A1 in Northumberland: Morpeth to Ellingham

7.6D Statement of Common Ground with Historic England

**Statement of Common Ground with
Historic England**

Rule Reference:	8(1)(e)
Planning Inspectorate Scheme Reference	TR010059
Document Reference	7.6D
Author:	A1 in Northumberland: Morpeth to Ellingham Project Team, Highways England

Prehistoric burial mound 420m north-west of East Linkhall

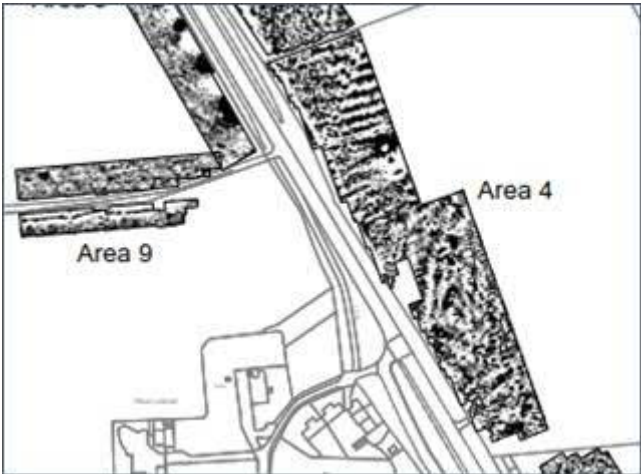
The information provided at this stage rightly highlights the proximity of this scheduled site to the proposed development. We broadly welcome the default position set out in the consultation, which is to avoid the scheduled area with any development activity.

However, we note that at this stage whether this avoidance is achievable, or whether the development will require an impact (up to the total destruction of the bowl barrow), is unclear. Clearly which of these scenarios applies makes a huge difference to the potential impact of the development on the historic environment, and how it needs to be treated in NPPF terms: total avoidance could mean the development avoids any impact, whereas development requiring removal of the monument would be regarded as substantial harm to this nationally-significant heritage asset, something that would require Highways England to provide clear and convincing justification (NPPF Paragraph 194) and to demonstrate that this harm is *necessary* in order to achieve substantial public benefits which outweigh this harm (NPPF Paragraph 195).

The scheme design has now been updated to remove the proposed detention basin from this location and to exclude the entire field containing this Scheduled Monument from the application boundary. The assessment will now be addressing potential impacts on this asset due to change in setting only.

West Linkhall Scheduled Monument

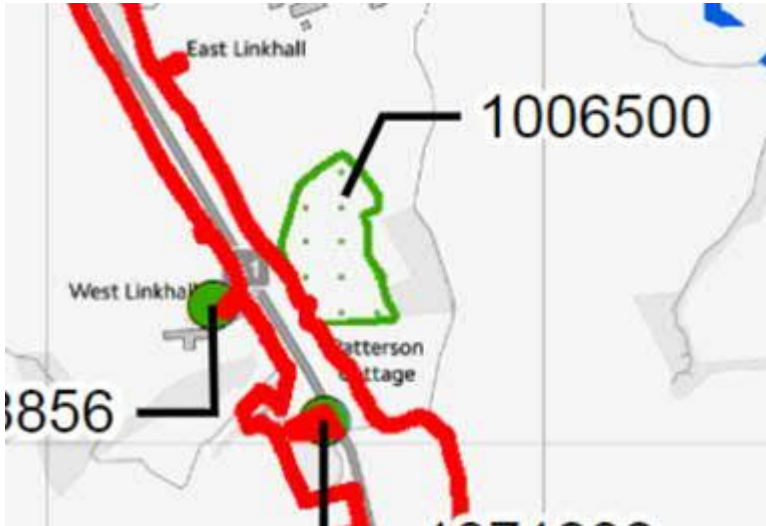
5.1	AG and MC discussed the conclusions of the assessment of impact on the setting of the Scheduled Monument. MC agreed broadly with AG's assessment that the impacts would not constitute substantial harm, however the information provided in October did not show the proposed dualled scheme or the proposed landscape mitigation. This needs to be reviewed before assessment confirmed.	AG to supply relevant extract from the landscape plan	ASAP
6	Statement of Common Grounds

The second query was the impact on the setting of the scheduled monument Camp at West Linkhall . Below is the scheme design in this location. The existing road will be widened to the east, towards the monument. There will be haul running along the east side of it. The current highway here is elevated and runs on an embankment, and the scheme design includes widening the embankment. The embankment will then drop towards the scheduled monument, but will fall short of its boundary. I have attached a photograph taken on the site (Image: Camp at Linkhall). This is taken from the north end of the site looking south. Please let me know if you need any more information.

West Linkhall Scheduled Monument

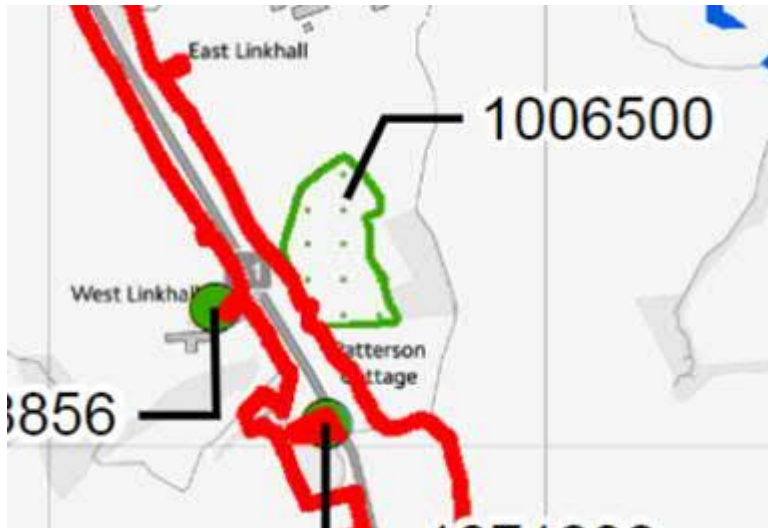
The second query was the impact on the setting of the scheduled monument Camp at West Linkhall . Below is the scheme design in this location. The existing road will be widened to the east, towards the monument. There will be haul running along the east side of it. The current highway here is elevated and runs on an embankment, and the scheme design includes widening the embankment. The embankment will then drop towards the scheduled monument, but will fall short of its boundary. I have attached a photograph taken on the site (Image: Camp at Linkhall). This is taken from the north end of the site looking south. Please let me know if you need any more information.
